Factory Service Bulletin

SUBJECT: MEMORYMOOG AUTOTUNE UPDATE BULLETIN: 840A DATE: 10/6/83
Serial numbers below 2723
Software Revision 2.4 (C, 0, ENTER displays 83)
Kit Part Number 997-044667-101

Pg. 23-26 - KEYBOARD, MONO & ARPEGGIATOR MODES

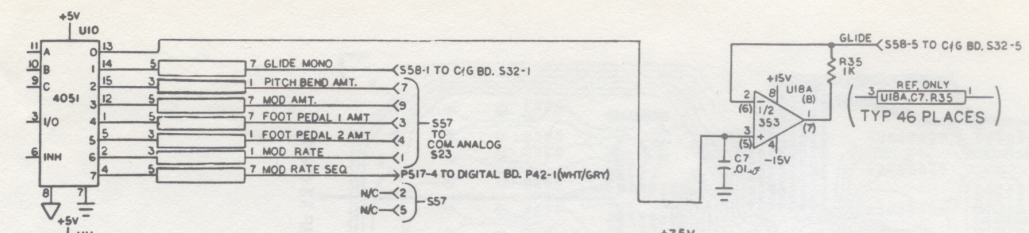
The displaying of keyboard and arpeggiator modes has been changed to make them easier to read and remember. The functions of the various modes, however, have not been changed. The previous modes referred to in the manual and the corresponding new modes are listed below:

KEYBOARD MODES		ARPEGGIATOR MODES		MONO MODES	
POLY 1	CYLIC	MODE 1	UP U	MONO 1	LATEST
POLY 2	MEM CYC	MODE 2	DWN U	MONO 2	LOW
POLY 3	RESET	MODE 3	UP DWN U	MONO 3	HIGH
POLY 4	MEM RES	MODE 4	UP L		
		MODE 5	DWN L		
		MODE 6	UP DWN L		
		MODE 7	AUTOTRIG		
		MODE 8	1 LAST U		
		MODE 9	1 LAST L

DMUX BOARD AUTOTUNE

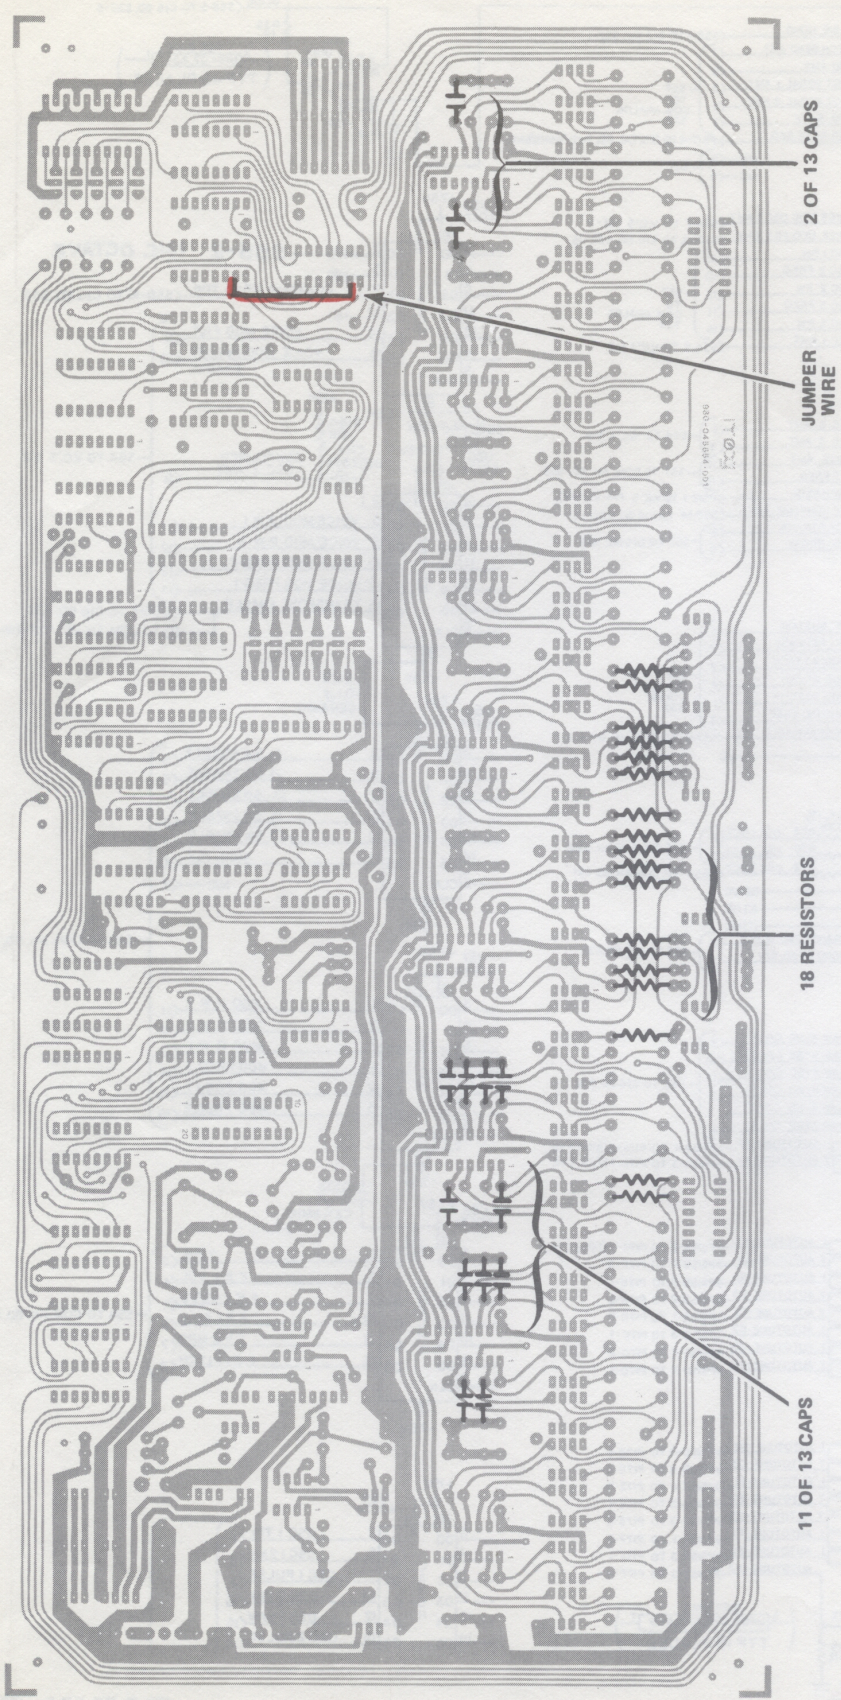
REPLACE THESE CAPACITORS WITH 75 WATT SOLDERING IRON
C45, C46, C41, C40, C39, C51, C52, C49 Replace with .047uf capacitors,
C48, C47, C50, C20, C18 (13 capacitors part # 946-041978-473.
mounted left to right and top to bottom).

REPLACE EVEN NUMBER RESISTORS FROM R84 THROUGH R118 WITH 45 WATT SOLDERING IRON.
R86, R84, R98, R96, R100, R92, R90, Replace with 17.4K 1%
R88, R94, R102, R114, R118, R104, resistors, part number R106,
R112, R108, R110, & R116 853-421742-031
'18 resistors as mounted from left
to right).

Add a 1.5" (38mm) insulated jumper from S-55 pin 2 to U54 pin 2 on the BOTTOM of the board (part number 996-045655-962).

1. IDENTIFY ALL PADS TO BE UNSOLDERED WITH A MAGIC MARKER (CAPACITORS REQUIRE 75 WATT SOLDERING IRON).
2. CHANGE ALL APPROPRIATE RESISTORS AND CAPACITORS AT ONE TIME.
3. SOLDER IN NEW COMPONENTS AND THE JUMPER WIRE.
4. THOROUGHLY CLEAN FLUX AWAY WITH ISOPROPYL ALCOHOL (THIS WILL ALSO REMOVE MAGIC MARKER).
